External Technical Review of Tank 48 at the Savannah River Site (SRS)

INDEPENDENT TECHNICAL REVIEW (ITR)
of the
PATH FORWARD
for
SAVANNAH RIVER SITE (SRS) TANK 48

**Independent Technical Review of the
Path Forward for Savannah River Site Tank 48**

ITR-T48-2006-001

Figure 4-1: Steam Reforming Process

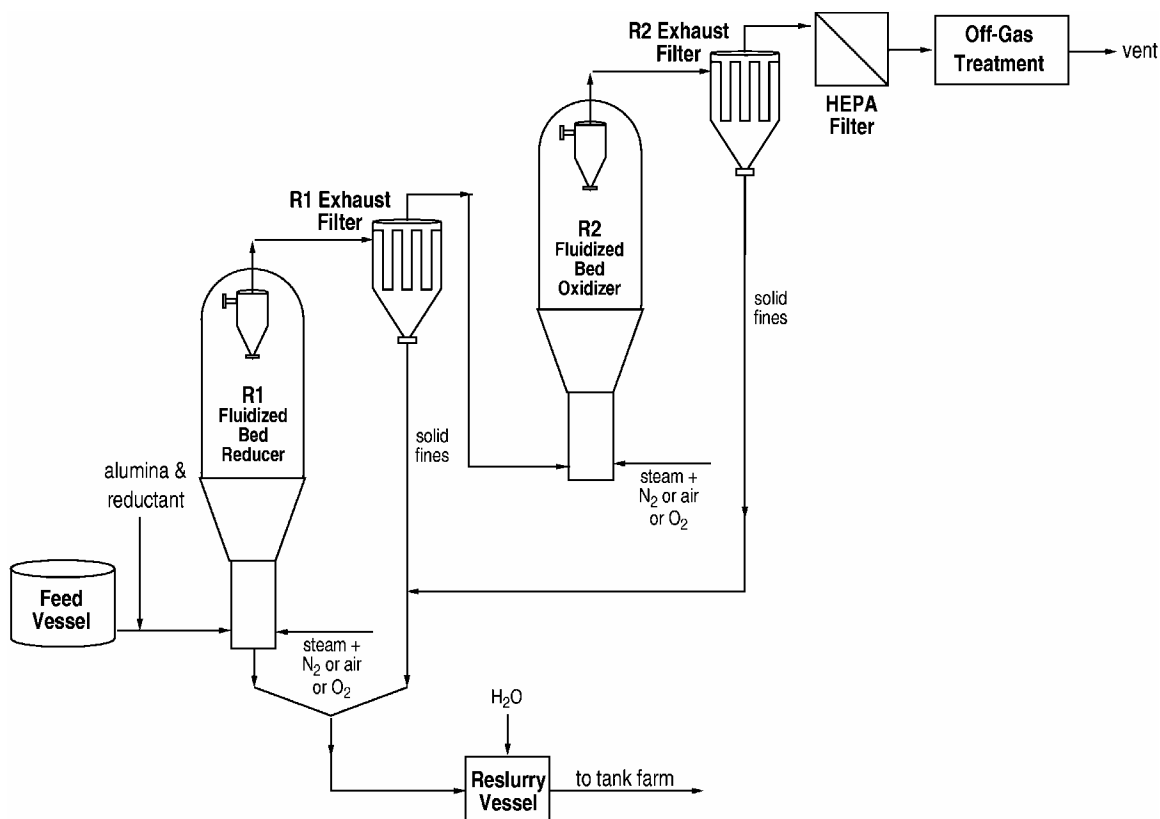
- Equipment design can be minimized by using lessons learned from much of the Hazen design and from the INL design.
- Preliminary design studies need to confirm that the Steam Reforming process, scaled to process at the necessary feed rate, can fit within the available space in the 241- 96H facility.
- A pilot plant (Hazen) exists which has a footprint consistent with the available space in the 241-96H facility. ‘Cold’ pilot plant runs are to be made on the Tank 48 slurry simulant in the next few months.

- Solids handling issues: 1) it should be demonstrated that fines do not escape the primary off-gas filtration system. 2) it is anticipated that solid bed products will not be transported to DWPF. Accordingly, conditions should be determined and demonstrated for producing a suitable slurry for transfer to the tank farm. 3) should solids coat Steam Reforming equipment, the design should provide for equipment decontamination;
- Agglomeration and defluidization: Operation ranges for flow rates of slurry feed, carbon source, alumina, O₂, fluidizing steam, and atomizing air that will avoid agglomeration and defluidization must be determined;
- Demonstrate acceptable level of mercury in the off gas: An appropriate mercury removal system may be required; and
- Perform a preliminary design to ensure that all of the necessary equipment can fit within the 241-96H facility.

Steam Reforming should be designated as the primary approach for treating wastes from Tank 48. Pilot-scale testing should be used to demonstrate the ability of the process to achieve a solid product compatible with DWPF processing requirements. Preliminary design evaluation should be used to verify process compatibility with 241-96H facility constraints.

Figure 4-3: Wet-Air Oxidation and Downstream Treatment Options

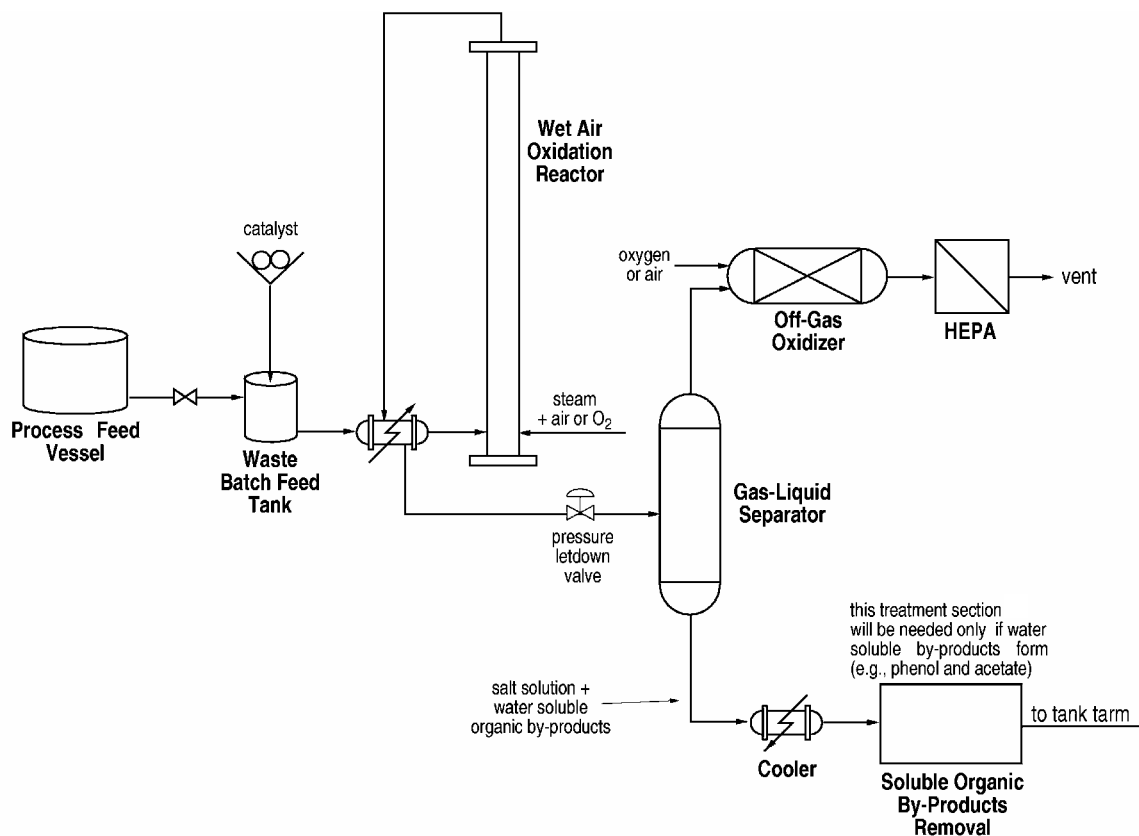
Without sufficient data for even a conceptual sizing of a WAO unit, only approximate size of potential WAO reactors can be estimated. Reactor size requires specifying a flow rate and a reaction time. If the waste in Tank 48 is concentrated to 10wt% solids, a 0.35 gal/min flow rate could treat the waste in approximately one year of processing with the expected plant availability. Even allowing for anticipated reactor down time, this is a reasonable processing rate.

Estimating a reaction time is more speculative. Zimpro experience suggests that a liquid residence time of approximately 1-hour and a gas residence time of about 10 minutes would be reasonable for WAO of TPB. These are only estimates from experience; they are not based upon test data. In a few months, the planned SRS sponsored tests at Zimpro will address the question of required residence time (and, thus, reactor size). These suggested residence times would require a reactor with a little more than 20 gallon volume, to process the contents of Tank 48 in approximately one year of processing with the expected plant availability of 50% and after the waste has been concentrated to 10wt%. That would not be an unreasonable size for the reactor, and it probably would fit in the 241-96H facility, along with the necessary support equipment. However, note that the support equipment required for WAO have not been designed and was discussed only qualitatively by the ITR Team. The height of the WAO reactor also could be a factor in fitting a WAO unit into the 241-96H facility. The typical height for WAO reactors is approximately 25-feet (Zimpro discussions, July 10, 2006). This height is reasonable and probably within the height available in the 241-96H facility, but the reactor could be made somewhat shorter if necessary.

- There is no experience in using WAO with highly radioactive waste. Although WAO oxidation is a mature technology, this lack of experience would require more design efforts for remote operations and maintenance.
- There are only preliminary data on destruction of TPB. This issue will be addressed during a planned contract from SRS to Zimpro. The brief tests planned should show whether TPB can be destroyed effectively and what degradation products are formed.
- Although it appears that a WAO system could fit into the 241-96H facility, that information would need to be confirmed by a preliminary design.

WAO should be designated a back up process. The planned testing program for WAO should be continued only to the point necessary to demonstrate the process viability and effluent compatibility with DWPF processing.

Figure 5-1: Tank 48 Bulk and Heel Treatment

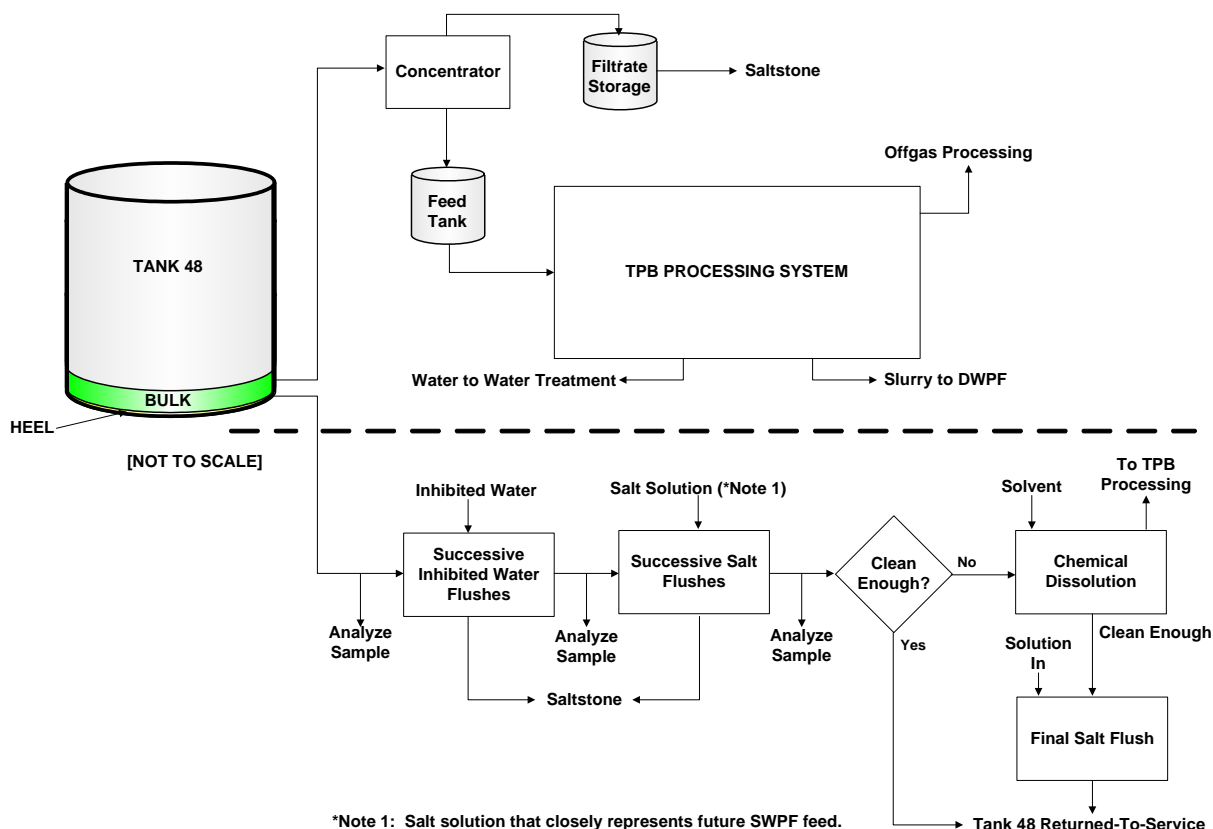
As envisioned by the ITR Team, the removal of the bulk and heel from Tank 48 would best be accomplished by a regimen of pump out, re-fill, re-slurry and pump out as shown in Figure 5-1. The initial tank contents are approximately 250,000 gallons and the majority of this volume, the bulk, will be transferred and processed through one of the methods discussed in Section 4 and diagrammed in the upper section of Figure 5-1. The heel will then be treated through a series of flushes and analyses (as indicated in the logic diagram in the lower portion of Figure 5-1). The discharged flush liquid with low Cs and TPB content will be processed through Saltstone.

12 Kg of TPB - the current acceptance criterion for Tank 48 return-to-service - is equivalent to about 2.7 gallons of solids. In a tank the size of Tank 48, a final residual 2-inches deep would be 7,000 gallons of slurry. Given the limitations in access for sampling, the likely non-uniformity and non-homogeneity of the residual and the inability to mix it effectively, it would be essentially impossible to confirm that standard had been met. Even if the criterion were raised significantly - say by a factor of ten - it would be very difficult if not impossible to verify compliance.

The ITR Team recommends that logic form the basis of a revised acceptance criterion for Tank 48 return-to-service. Specifically, the measured quantity of TPB in salt solution flush effluents, with adequate margin, should be used to conservatively predict TPB which can be transported during tank reuse after return-to-service, with supporting calculations to demonstrate that such TPB quantities cannot create downstream flammability or other hazards.

Figure 6-1: Sequential Schedule

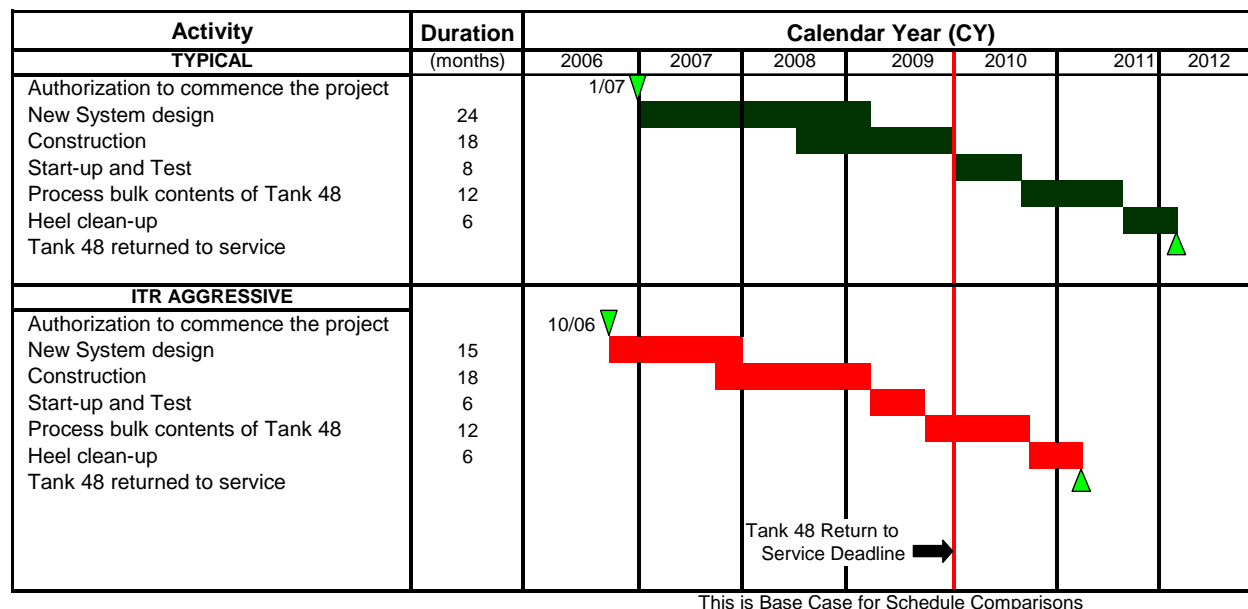
As shown in Figure 6-1 the time span to complete all the steps needed to achieve Tank 48 return-to-service, in the currently planned sequence, and using typical durations for critical path adjusted, is estimated to be 63 months. Starting the sequence in January 2007 would result in Tank 48 not being available before mid 2012. So conducting the activities in series does not come close to achieving the Tank 48 return-to-service date of January 2010.

The ITR Team notes that it is possible to improve upon this typical schedule for engineering, construction and start-up work. With early start, significantly compressed engineering schedule (based on work already accomplished in Steam Reforming), strong management and controls, and rapid turnaround on required permits and approvals – and no major upsets or delays – the team considers that the typical schedule can be improved by about a year. This “aggressive schedule” is also shown on Figure 6-1. Even with success to that degree, however, Tank 48 is not returned-to-service until more than one year after the January 2010 need date.

In summary, the ITR Team believes the current sequential path strategy to be incompatible with the required date of January 2010 for Tank 48 return-to-service. A delay by more than one year is very likely, and by more than 2 years is very possible. A way to address the sequential schedule conflict is discussed in the Section 7.
